**Title:** Result of voting on ISO/DIS 19115 Geographic information - Metadata

**Project:** 19115

**Status:** Result of voting. Comments received from OGC are included at the end.

### **B.2.1 changes**

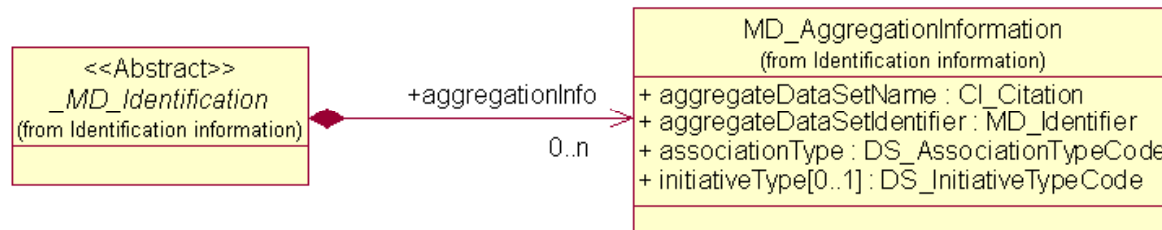
Member body	Clause/ subclause	Paragraph/ Figure / Table	Type of comment (general/ technical/editorial)	Comment	Proposed change	Observations of the secretariat on each comment submitted
OGC	6.2 B.2.1 B.2.2	Figure 3 Figure A.1 Figure A.2	Editorial	The part-whole relationships between datasets and aggregates are shown in Figure 3. However, the DS package is not fully documented in Annex A and Annex B.	<p>Add the attribute 'dataSet' to MD_Metadata to represent the dataset to which metadata applies. See Attachment A for a summary of changes to the associated figure(s) and data dictionary.</p> <p>Create/add a new class 'MD_AggregateInformation' to the Identification information package to represent dataset aggregation information. See Attachment B a summary of changes to the associated figure(s) and data dictionary.</p> <p>Create an aggregate relationship between MD_AggregateInformation and MD_Identification with a role named "aggregationInfo" of cardinality of [0..*] (see Attachment B).</p>

The data dictionary of MD\_Metadata (B.2.1 Metadata entity set information) will change as follows. Note that the 'dataSet' attribute will be inserted as Item 12 and that the remaining items (Items 12 – 22) will be renumbered as items 13 – 23.

Name / Role name	Short Name	Definition	Obligation / Condition	Maximum occurrence	Data type	Domain
12.	dataSet	dataSet	Identifies the location (URL) of the dataset to which the metadata applies	M	1	CharacterString	Free text
